SB, New Motor/Cutter Arm, K7000 Family, 2021-11

SYMPTOM/DESCRIPTION

Figure 1: New Motor with steering pins.

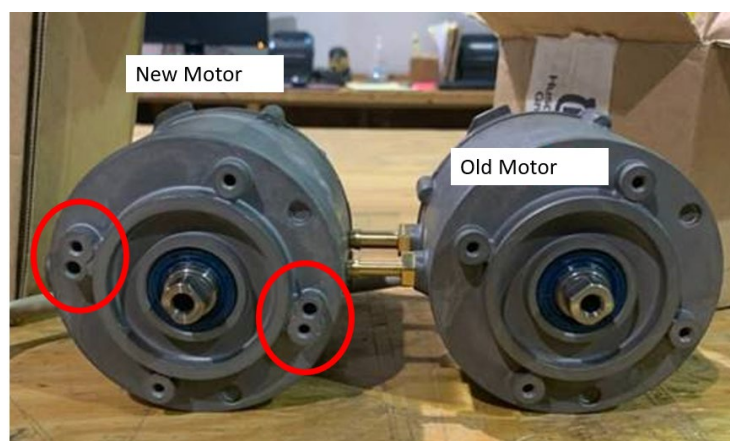
Field reports has shown that the screws holding the cutter arm to the motor on K7000 family can come lose and damage the motor. In order to improve this we have implemented steering pins on the motor (figure 1) and corresponding holes on the cutter arm (figure 2) to hold the two pieces in a fixed position.

- To upgrade to the new system or if a new motor is needed, please order the MOTOR KIT, see *Parts Information* table.
- Once the upgrade is done it is possible to order the CUTTER ARM separately, see *Parts Information* table.
